Friends of Moonee Ponds Creek Inc

SUBMISSION - MELBOURNE PLANNING SCHEME AMENDMENT C417 MACAULAY STRUCTURE PLAN 2021

Table 2: Site setback

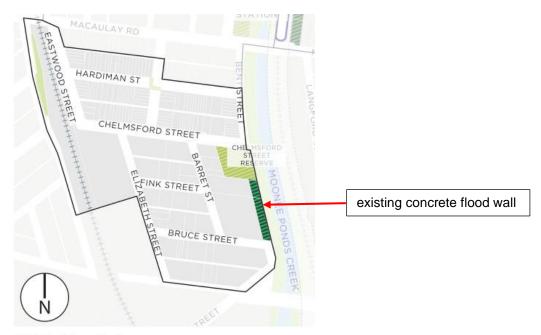
- What measure is used to determine "limits" overshadowing of the Moonee Ponds Creek corridor? Are 5%, 10%, 30%, 50% overshadowing acceptable limits?
- Mandatory site setback from the Creek corridor is cited (Table 2): '15 metres from the boundary of the Moonee Ponds Creek'. But what constitutes the 'boundary' – the existing concrete flood wall or the top bank of the waterway itself – which are

significantly different measures. This must be clarified so as to be consistent with the diagram and should read:

15 metres from the western boundary of Moonee Ponds Creek as defined by the concrete flood wall.
